**FINAL ENVIRONMENTAL IMPACT STATEMENT FOR  
HYDROPOWER LICENSES**

**BIG CREEK ALP PROJECTS**

**Docket Nos. P-67, 2175, 2085, and 120**

Figure 2-1. Existing facilities in the Big Creek System. (Source: FERC, 2002)

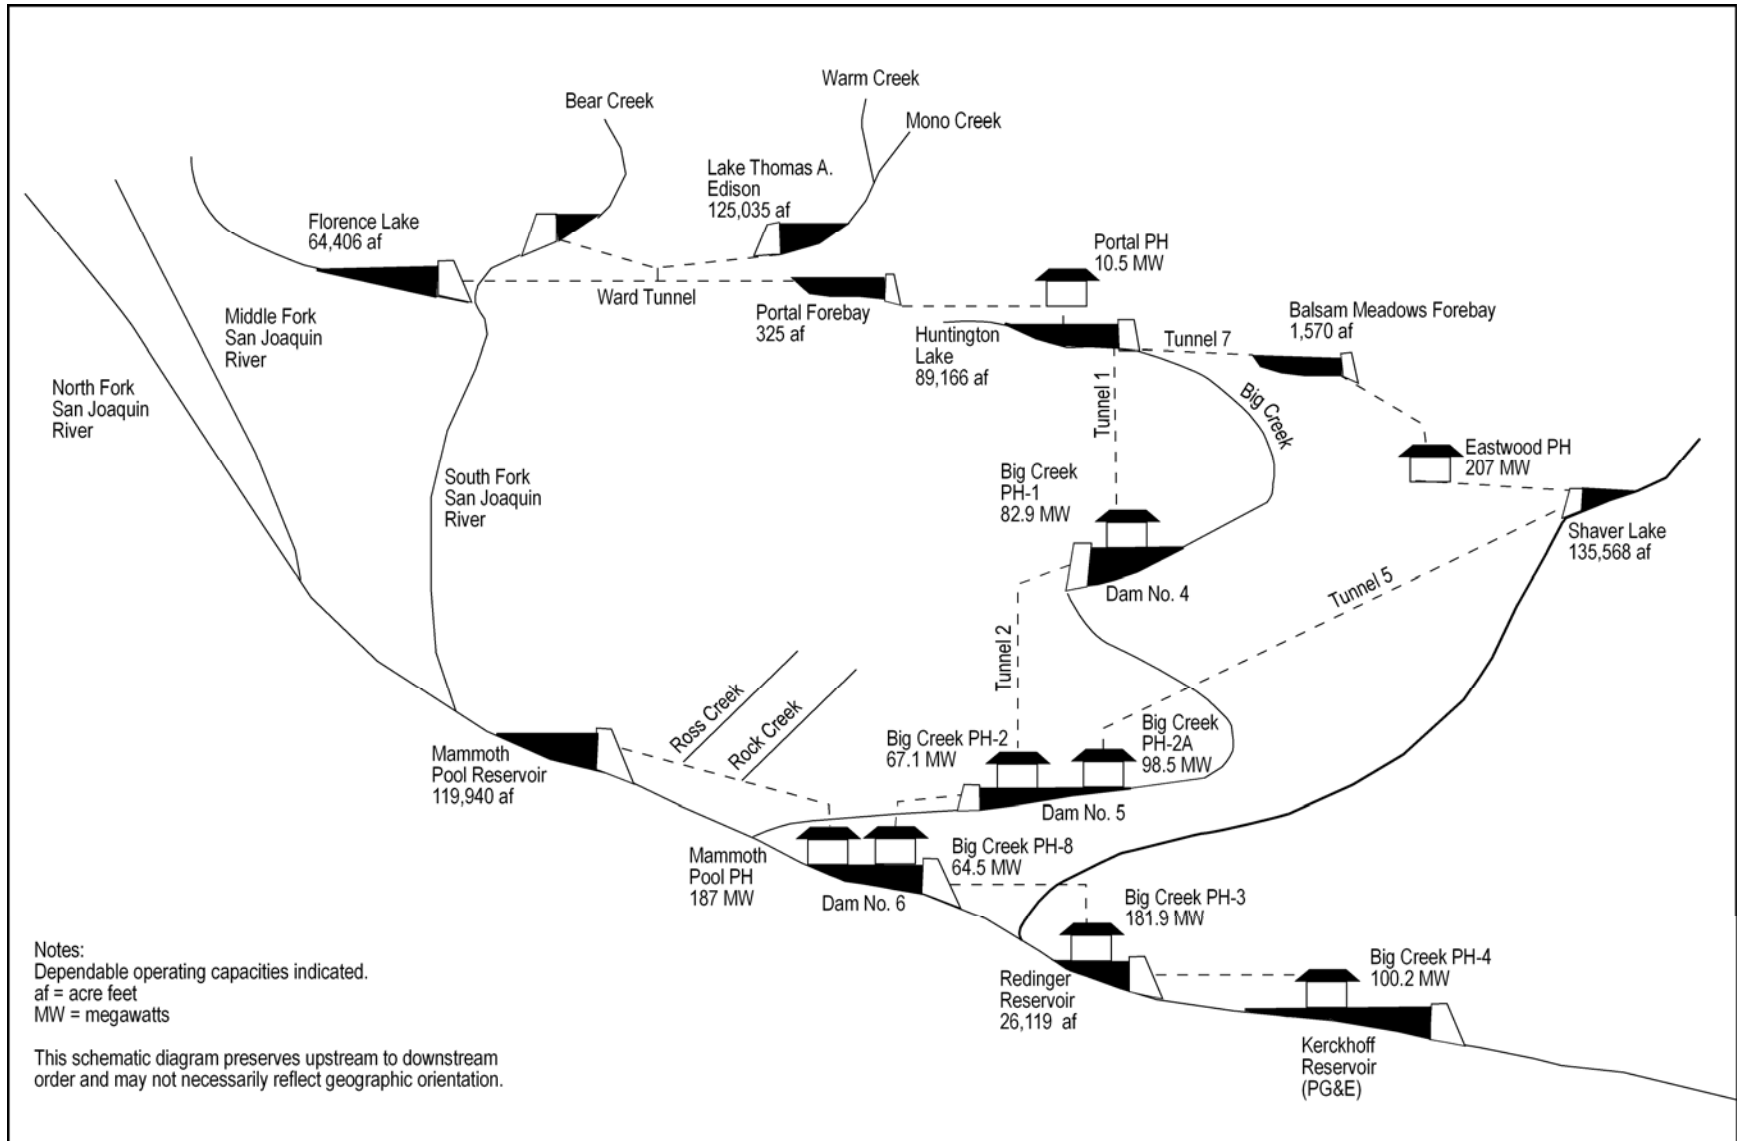
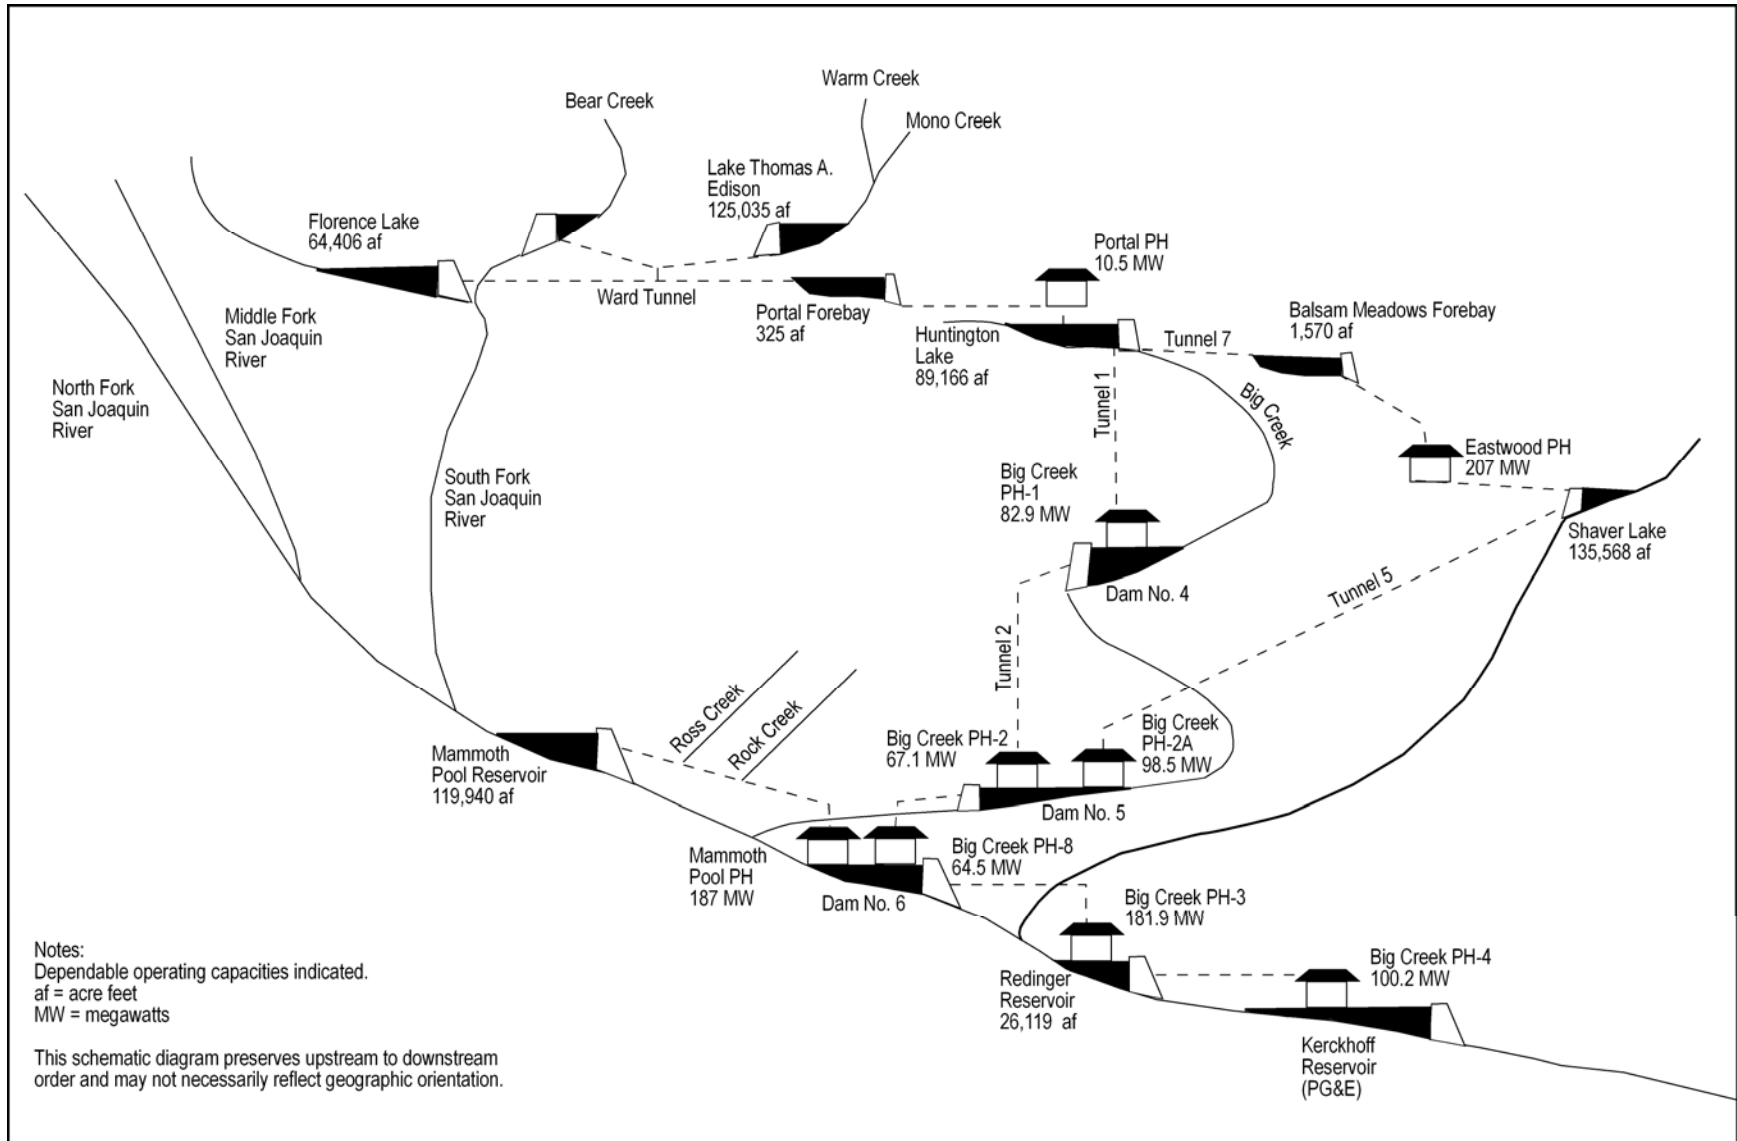
**Comment 13:** SCE recommends modifying the dependable operating capacity values shown in figure 2-1 as follows: (1) Big Creek powerhouse 2A should be 98.5 megawatts (MW); (2) Big Creek powerhouse 1 should be 82.9 MW; (3) Mammoth Pool powerhouse should be 187 MW; and (4) Big Creek powerhouse 3 should be 181.9 MW. In addition, Florence Lake usable storage is 64,406 acre-feet.

**Comment 14:** The Forest Service notes that the schematic shown in figure 2-1 (page 2-3 of the draft EIS) does not indicate that Balsam Creek releases from the forebay are recaptured downstream within the Big Creek System.

**Response:** We have adjusted figure 2-1 to more accurately reflect the description of various project features.

**Response:** The purpose of figure 2-1 is to show the geographical relationship of existing project facilities associated with the Big Creek System, not the flow through the system. The complex nature of flows through the Big Creek System, including the fate of water released to Balsam Creek from the Balsam Meadows forebay, is shown in figures 3-1 (page 3-5 of the draft EIS) and 3-6 (page 3-46 of the draft EIS).
